Fort Mill School District Addendum #2	Solicitation Number: #23-007
		Date Issued: December 15, 2023 Procurement Specialist: Kelly Keniston Phone: (803) 548-8202 E-Mail Address: kenistonk@fortmillschools.org

DESCRIPTION Springfield Middle School Cooler & Freezer Enclosure Replacement

Addendum #2 is being issued to answer questions submitted by bidders and include additional information for the contract set of documents.

2 FLOOR PLAN
A30 1/8" = 1'-0"

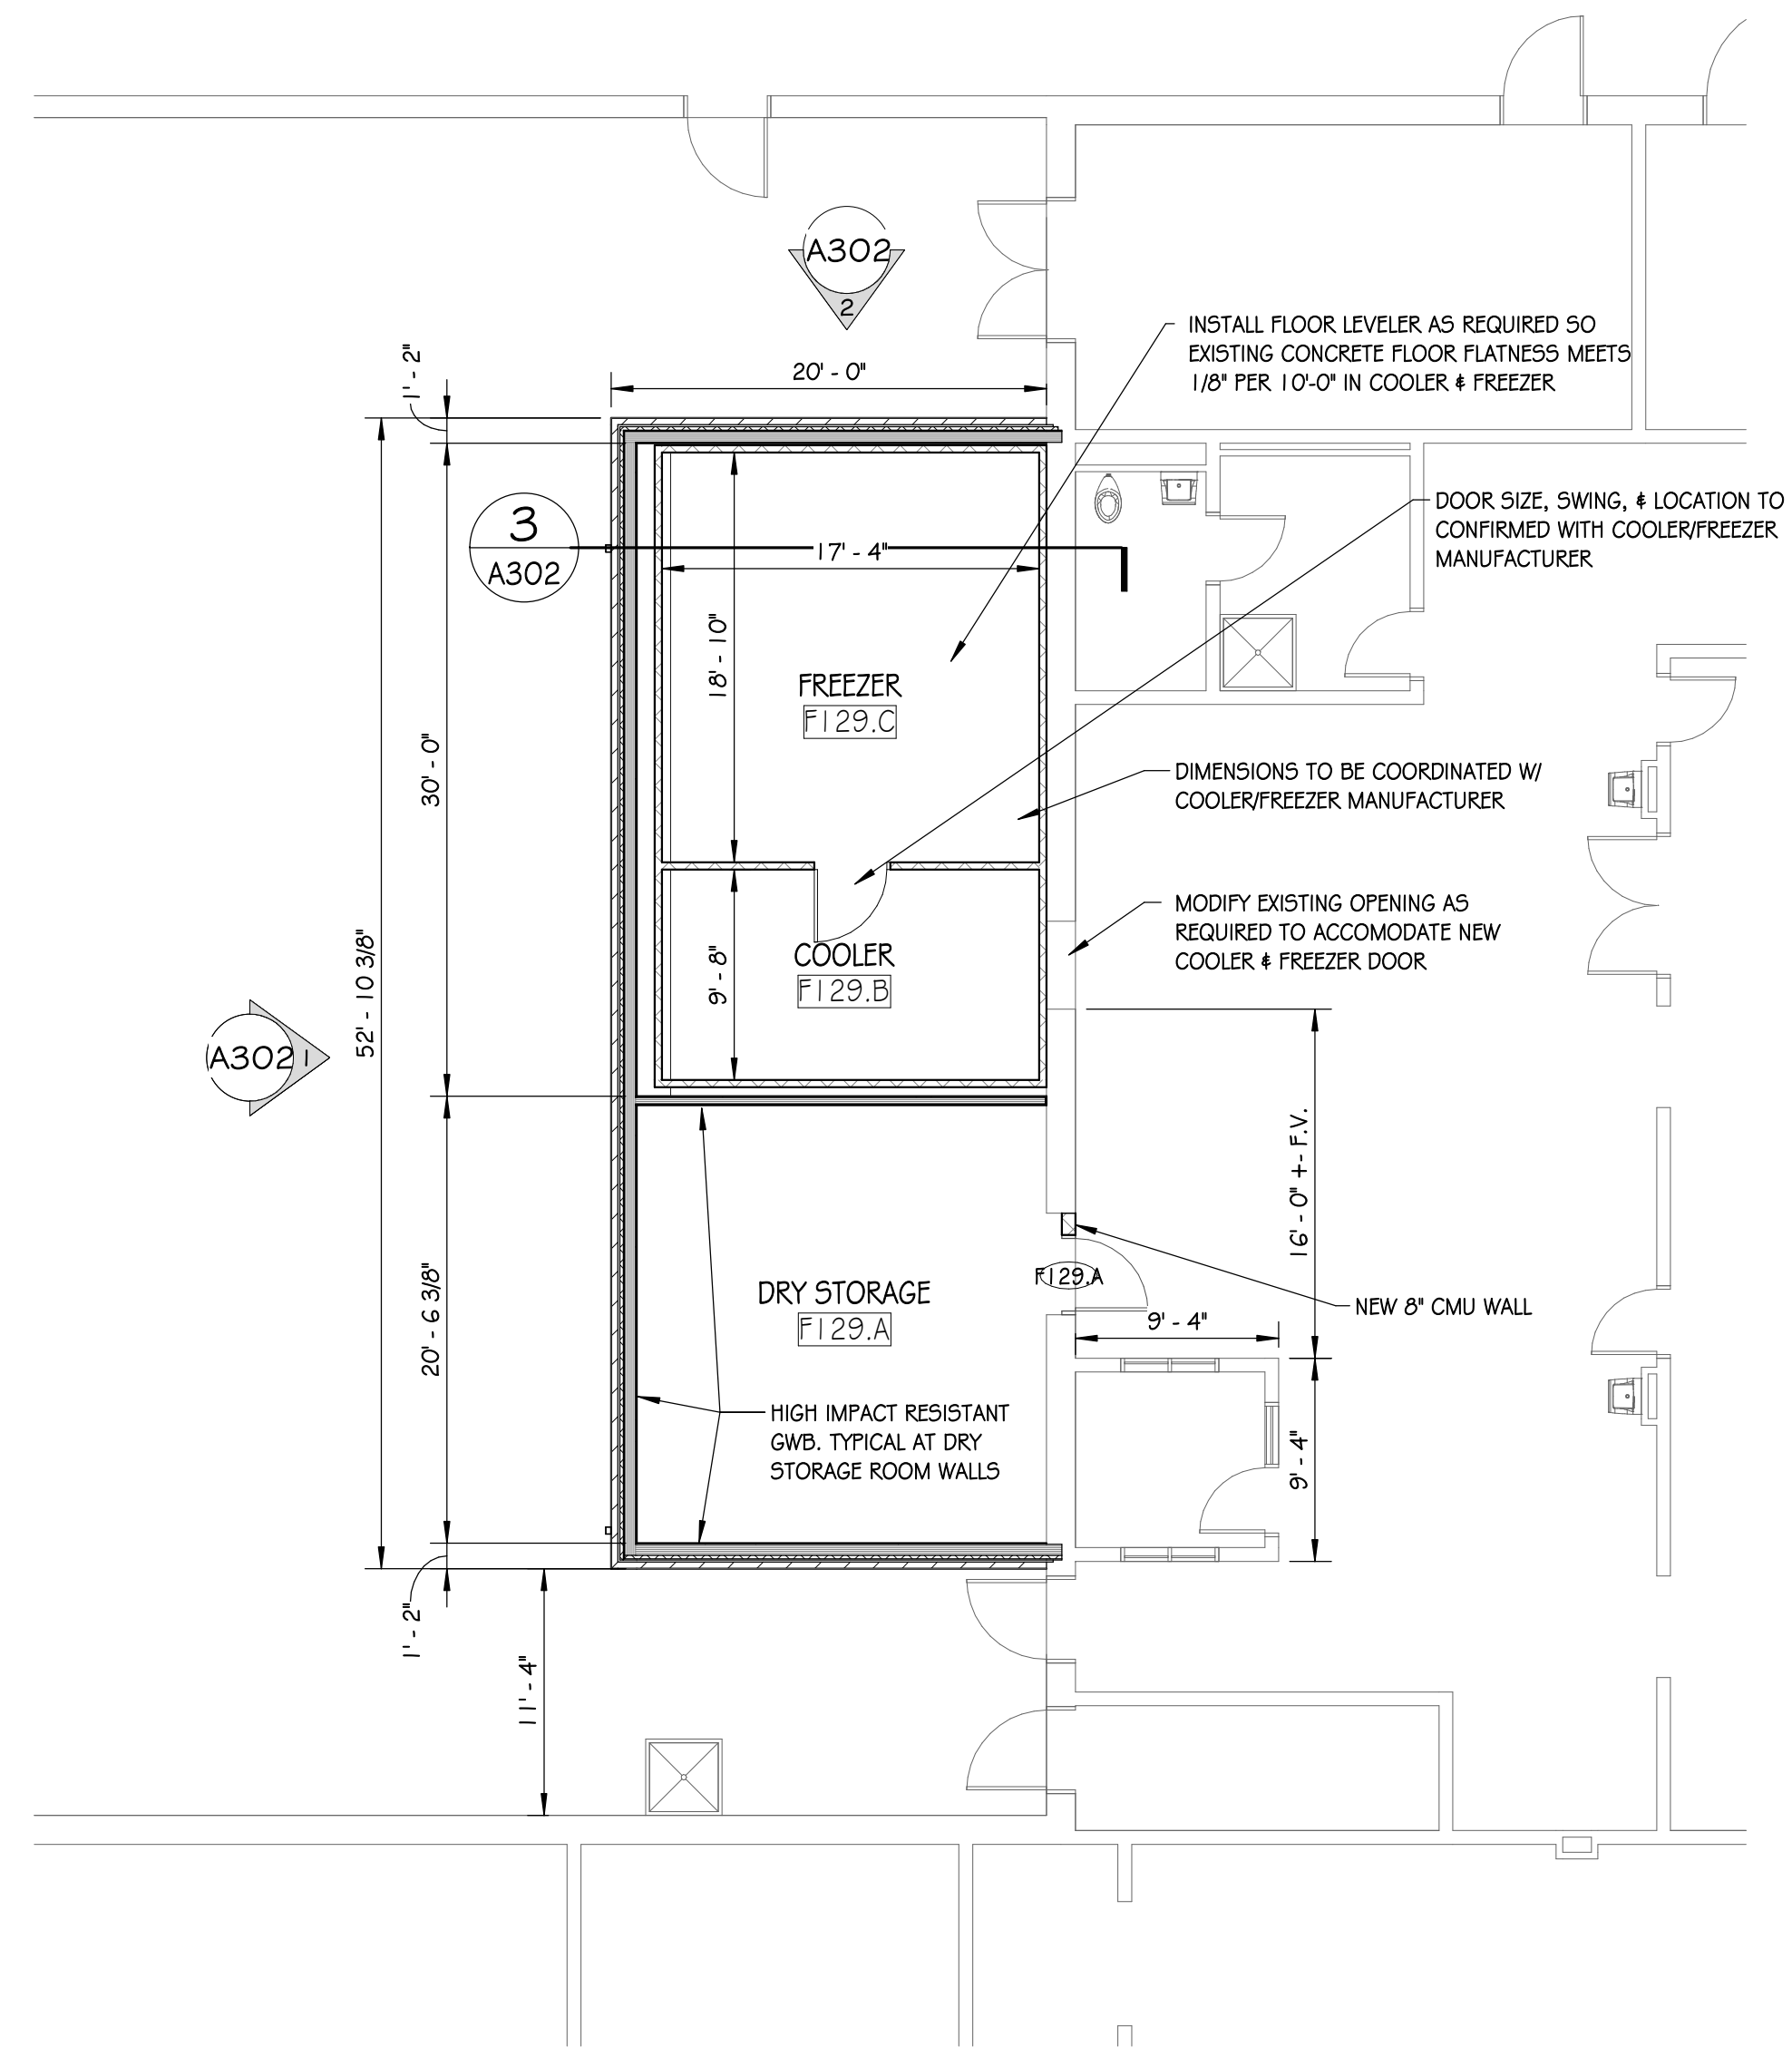
Per one of our refrigeration equipment contractors, there needs to be a 2” minimum gap surrounding the entire cooler/freezer enclosure. Per the Floor Plan on 2/A301, the unit is showing butting up against the school building, which it cannot do. Please advise?

A: The GC is responsible for proper coordination of placement of Cooler/Freezer to ensure all Manufacturer requirements are met.

3 ROOF PLAN
A30 1/8" = 1'-0"

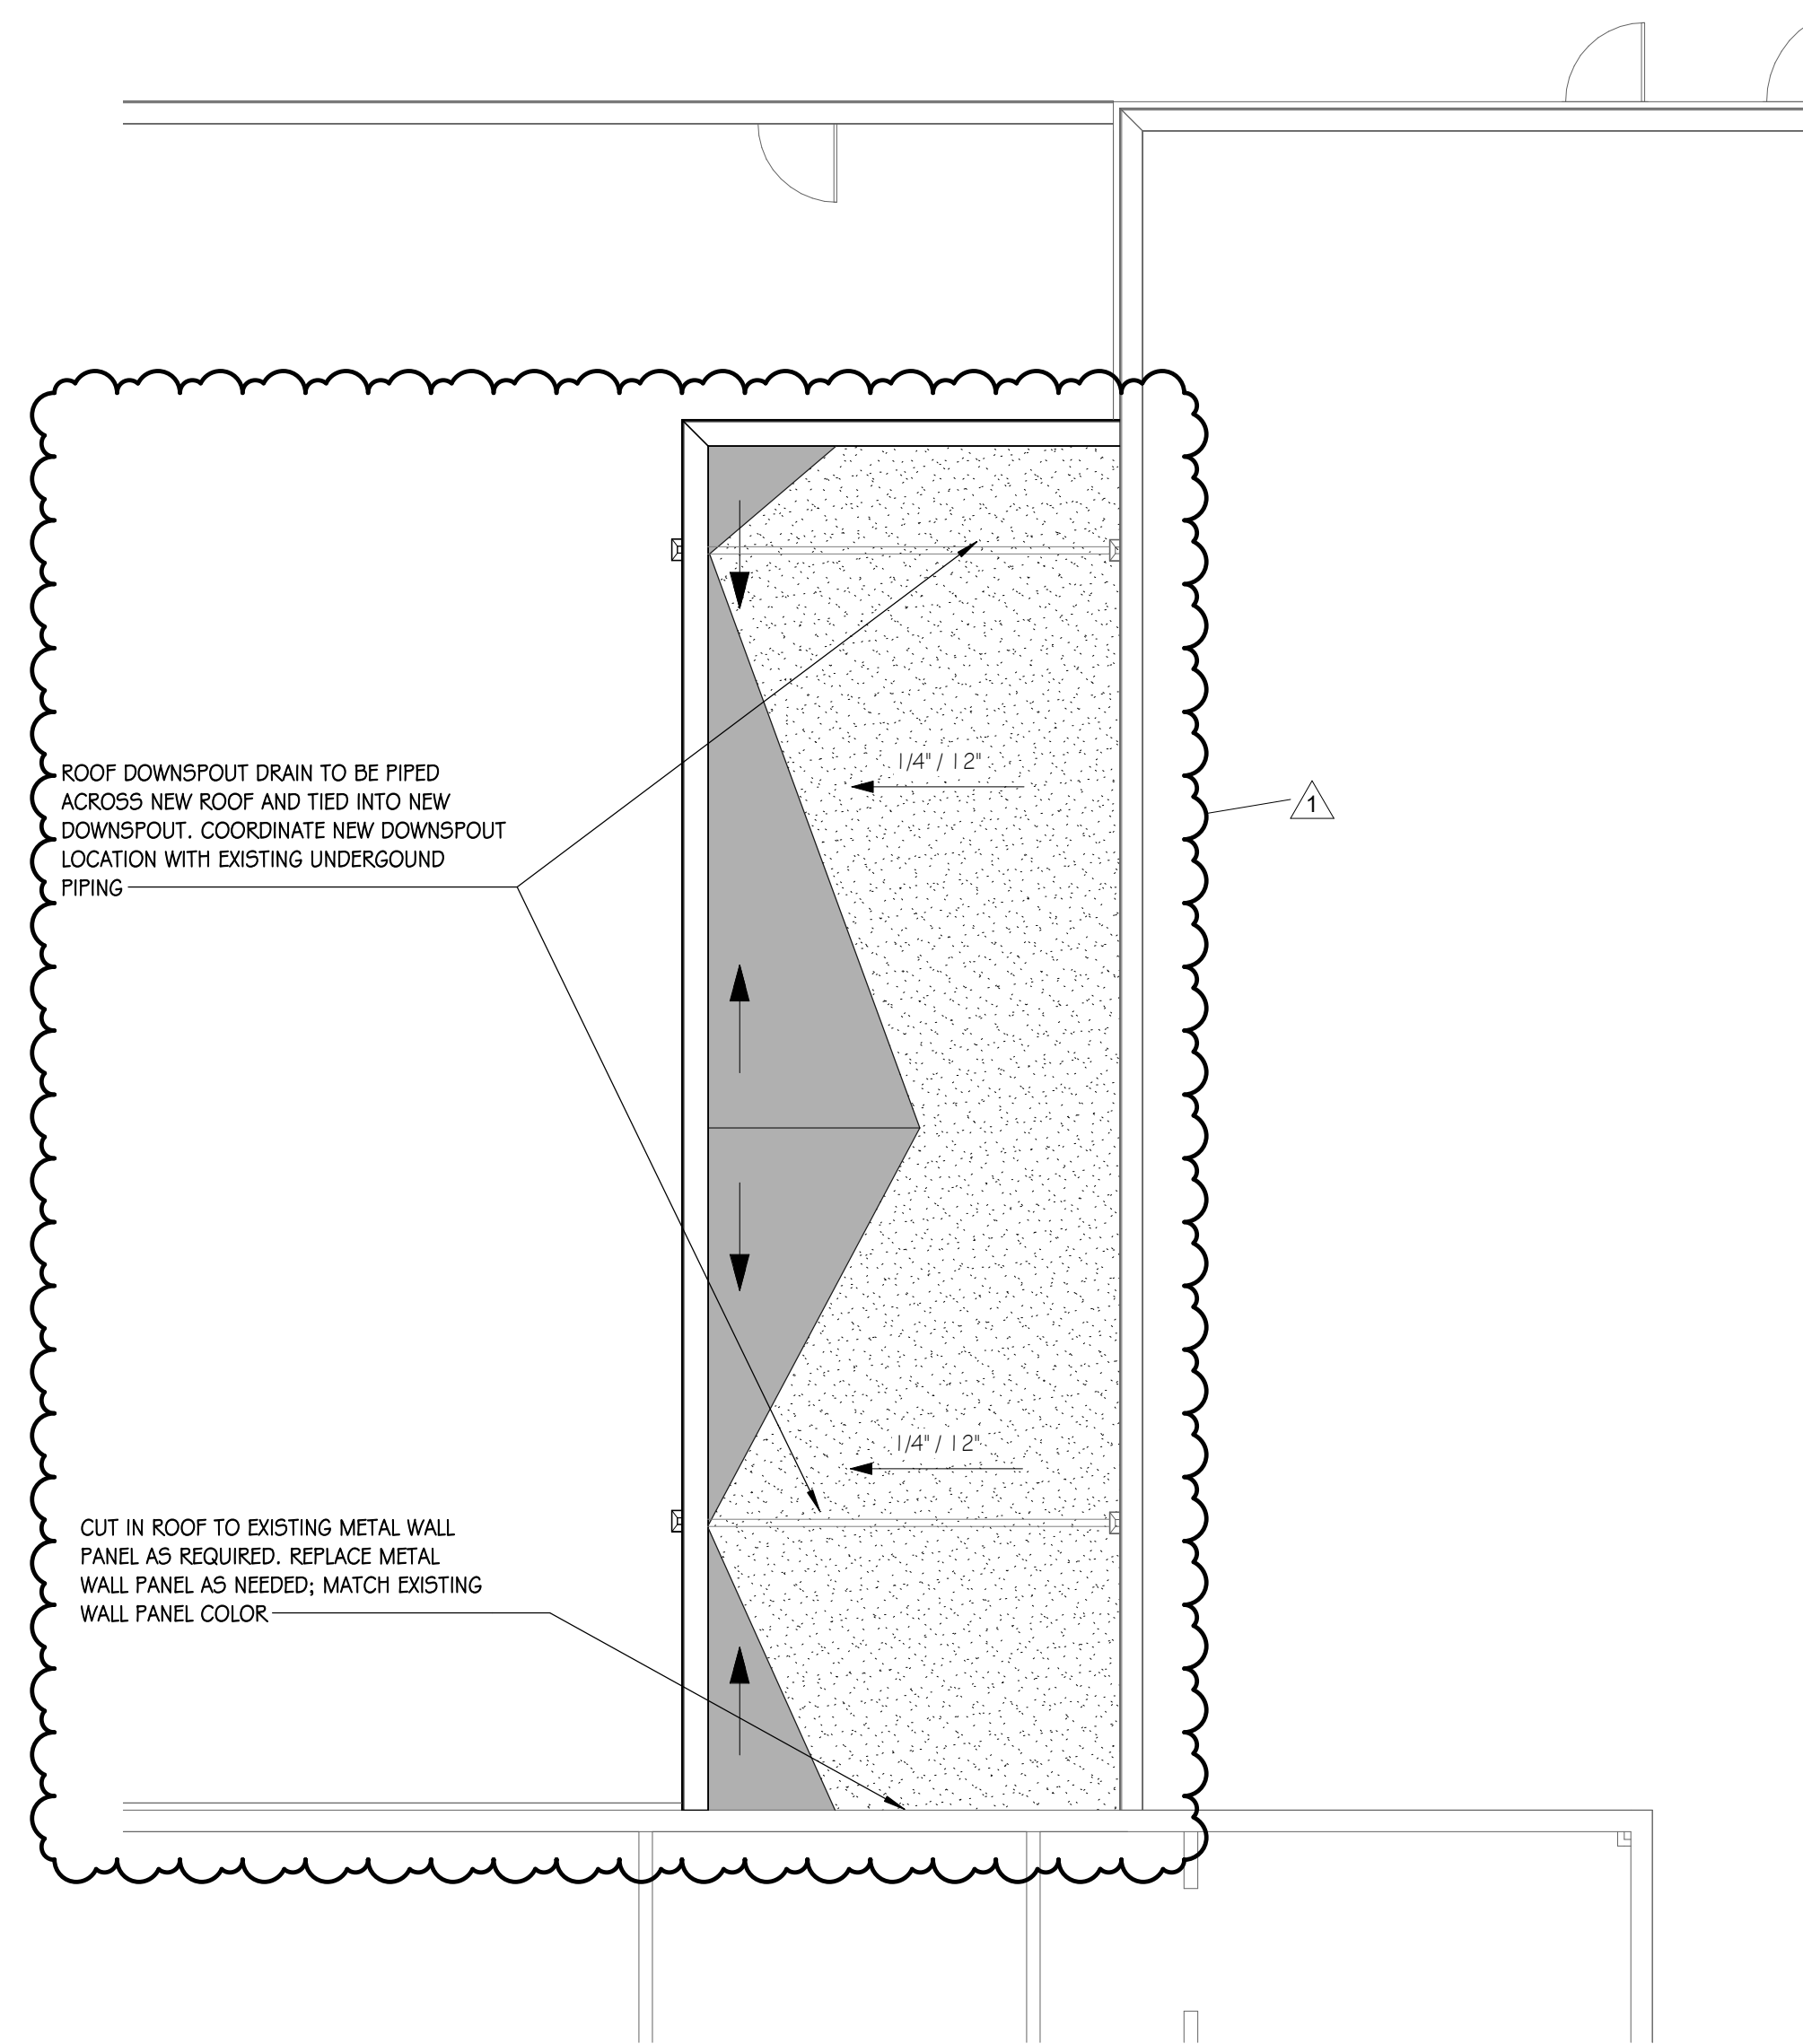
Wall Sections 3/A302 seems to show the downspouts from the school roof connecting to the scuppers from the new cooler/freezer roof. That is not shown on the Roof Plan 3/A301. Are they to be installed to the drains similar to what is on the existing structure??

A: Please refer to the revised Sheet A301 / Detail 3 indicating the routing of the roof leaders from the upper roof to the new down spouts for the New Cooler & Freezer roof. These items are required to be piped across the new roof, similar to the existing installation.
